T10/1711-D

Comment Resolution Tally	
Integrated into SAT-r08d:	1404
Rejected:	96
Cancelled (e.g., withdrawn):	118

Information technology - SCSI / ATA Translation (SAT)

Summary of Comments on SCSI / ATA Translation Standard

Figure 2 — ATA document structure

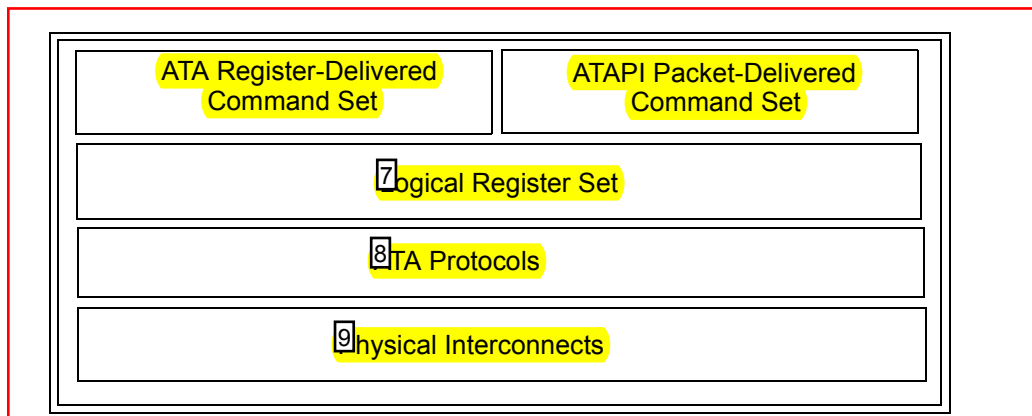
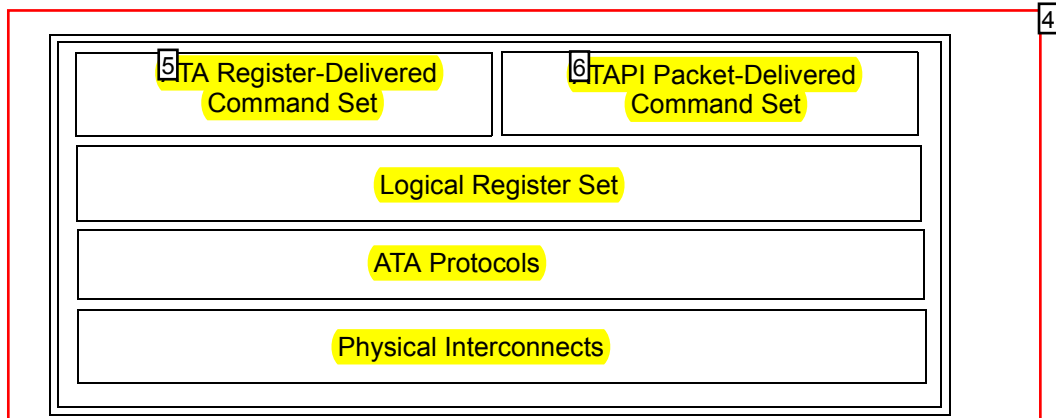
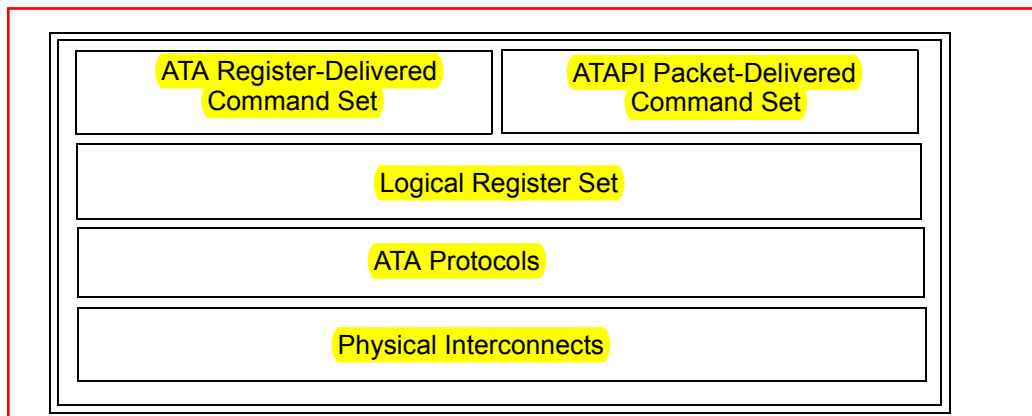
T 1 Scope, the line just before figure-2
Change "ATA/ATAPI-7" to "ATA8".

T Remove the period below the words "Figure 2 shows ..." and above the actual Figure 2.

T In Figure 2
change
"ATA Register-Delivered Command Set"
to
"ATA register delivered command set"

T In Figure 2
change
"ATAPI Packet-Delivered Command Set"
to
"ATAPI packet delivered command set"
RESOLUTION: s/b "ATAPI packet delivered command sets", for consistency with ATA8-ACS.

T This layer doesn't appear in ATA/ATAPI-7
Figure 2
change
"Logical Register Set"
to
"ATA logical register set"
RESOLUTION: Delete the box containing "Logical Register Set" as it doesn't appear in ATA8-ACS.

T Figure 2
change
"ATA Protocols"
to
"ATA Transport Protocols"

T Figure 2
change
"Physical Interconnects"
to
"ATA physical interconnects"

Figure 3 — SCSI/ATA translation document role

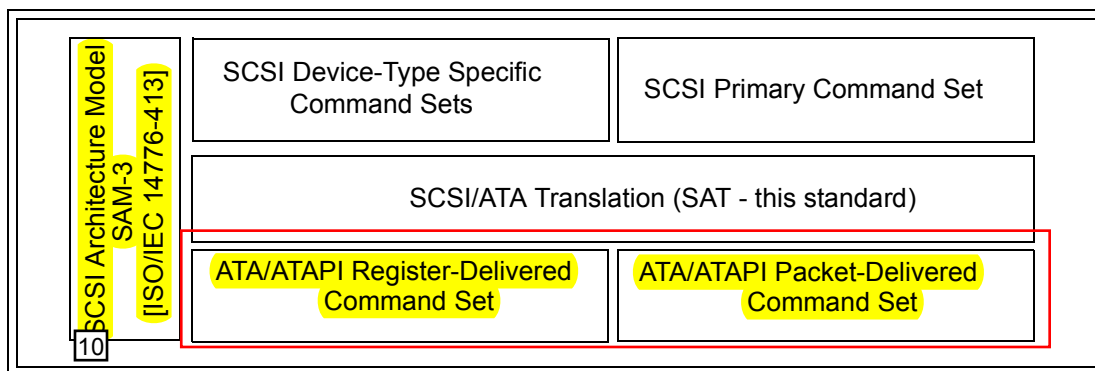
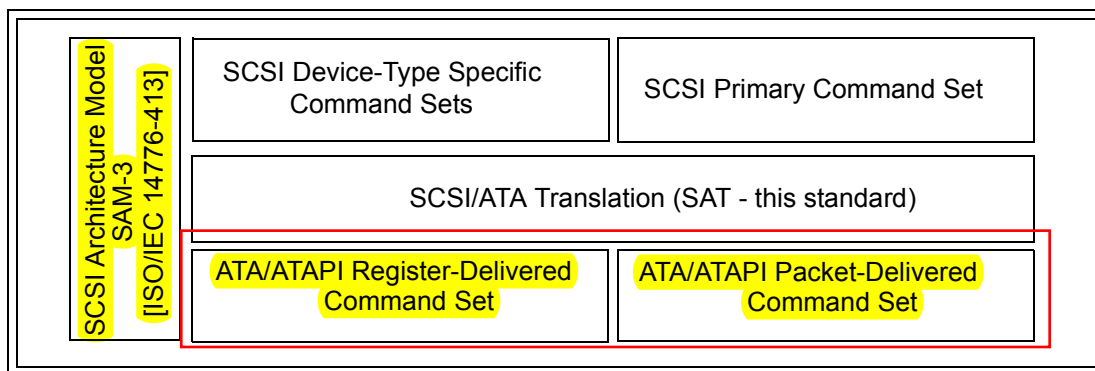
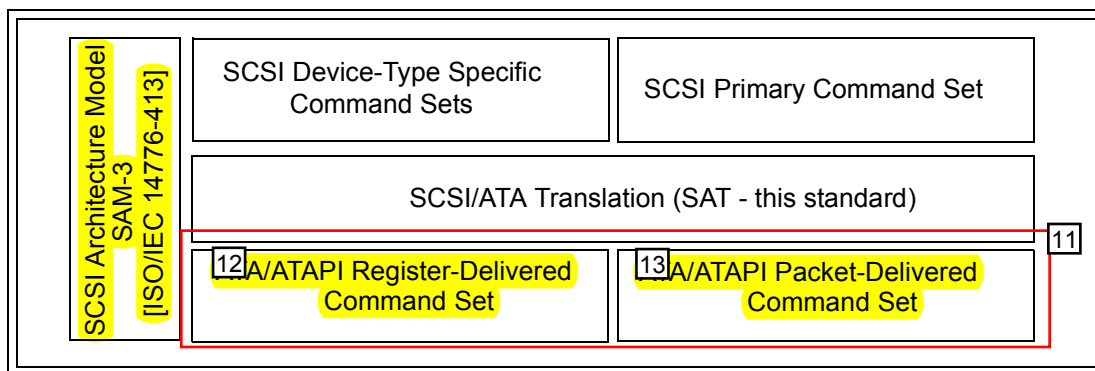
T In Figure 3, remove
"SAM-3
[ISO/IEC 14776-413]"

Figure-3, bottom two boxes:

In Figure 3

In Figure 3

Figure 4 — SATL functional protocol reference model

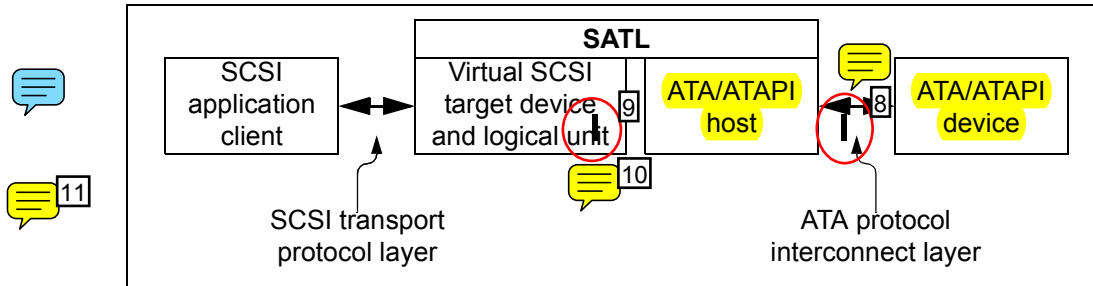
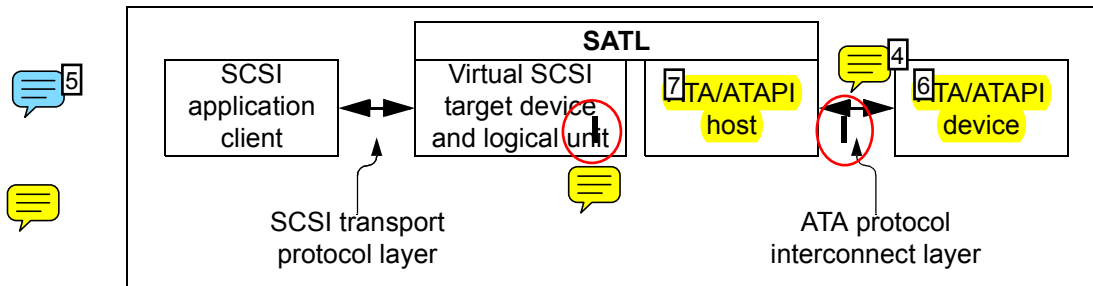
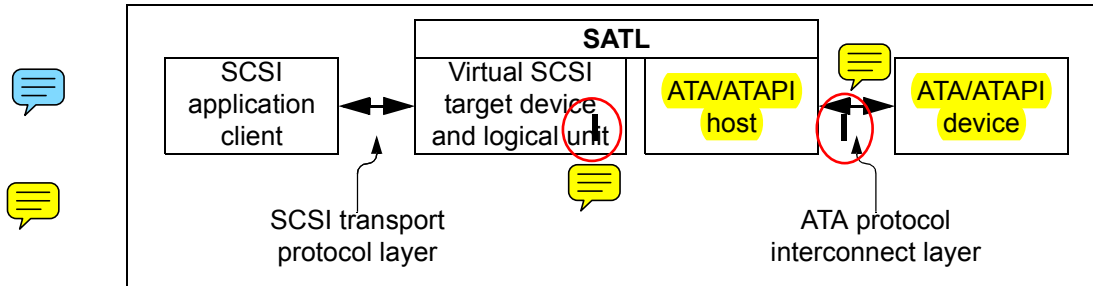
Figure 4 - SAT functional protocol reference model
change
"ATA/ATAPI host"
to
"ATA host"

5.1
figure 4
remove extra lines in figure

Figure 4
This figure has some strange fat lines in it that need to be removed.

1. Remove what look like change bars in Figure 4
2. Change "logical unit" to "logical unit(s)"
3. Change "ATA protocol interconnect layer" to "ATA transport protocol interconnect layer"

Change the figure title to: "Figure 4 - Example of a SATL between a SCSI application client and an ATA or ATAPI device", fix change bars, and the change in item-3 as well.

Figure 5 — Identification descriptors included by a SATL in an ATA host

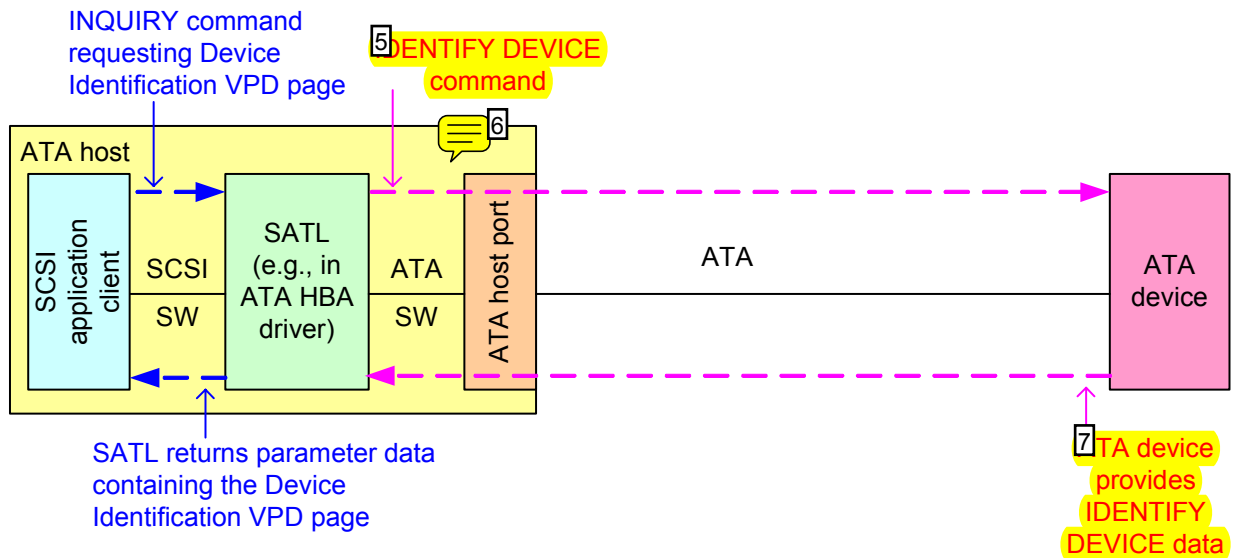
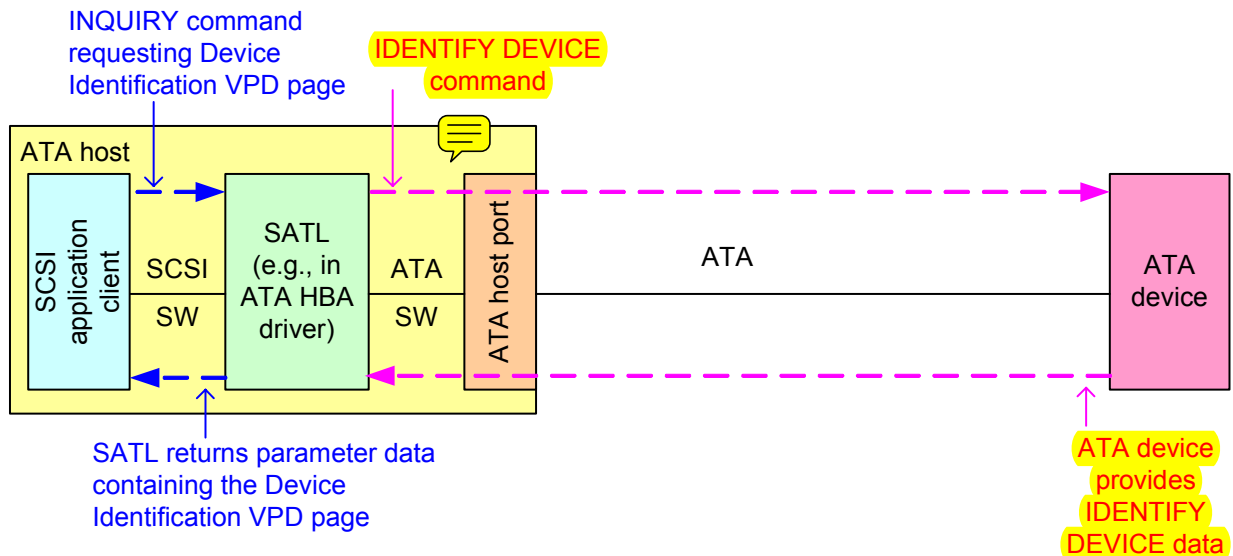
T In **Figure 5 — Identification descriptors included by a SATL in an ATA host**
change
"IDENTIFY DEVICE command"
to
"ATA IDENTIFY DEVICE command"

T In **Figure 5 — Identification descriptors included by a SATL in an ATA host**
change
"ATA device provides IDENTIFY DEVICE data"
to
"ATA device returns ATA IDENTIFY DEVICE data"

Figure 6 — Identification descriptors included by a SATL in a SAS initiator device

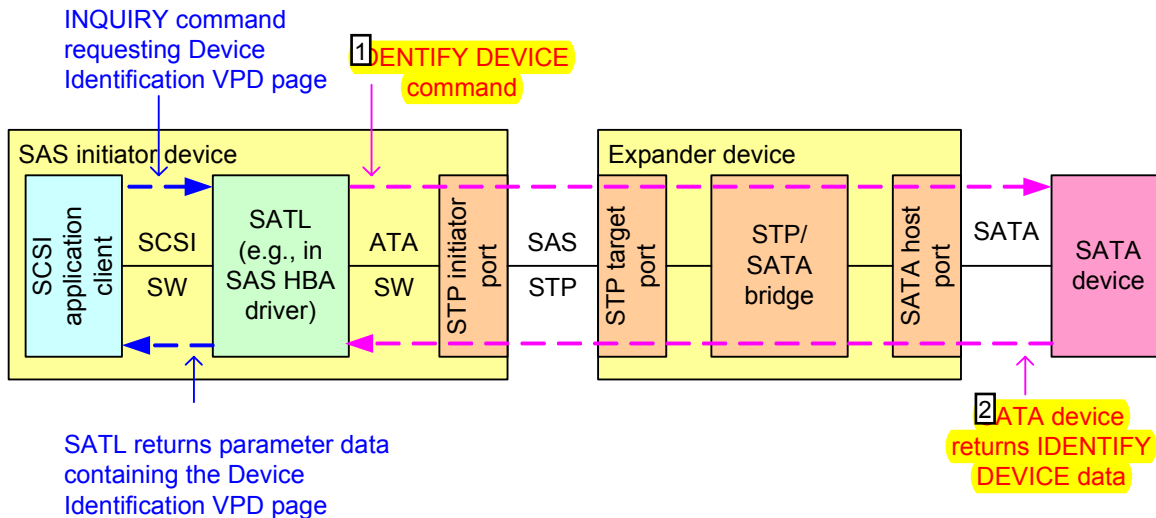
T In Figure 6 — Identification descriptors included by a SATL in a SAS initiator device

T In Figure 6 — Identification descriptors included by a SATL in a SAS initiator device

Figure 7 — Identification descriptors included by a SATL in a SCSI to ATA protocol bridge

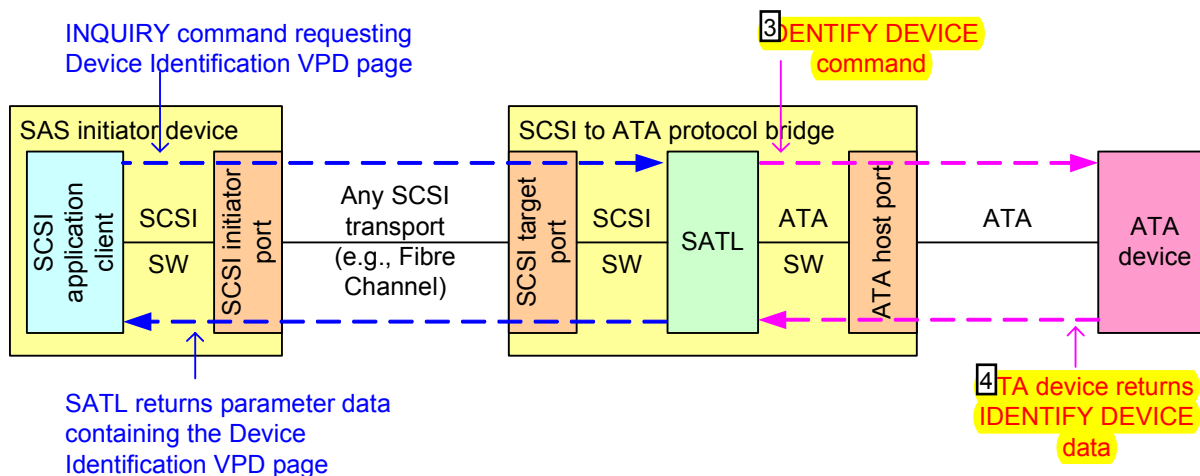
T In **Figure 7 — Identification descriptors included by a SATL in a SCSI to ATA protocol bridge**
change
"IDENTIFY DEVICE command"
to
"ATA IDENTIFY DEVICE command"

T In **Figure 7 — Identification descriptors included by a SATL in a SCSI to ATA protocol bridge**
change
"ATA device returns IDENTIFY DEVICE data"
to
"ATA device returns ATA IDENTIFY DEVICE data"
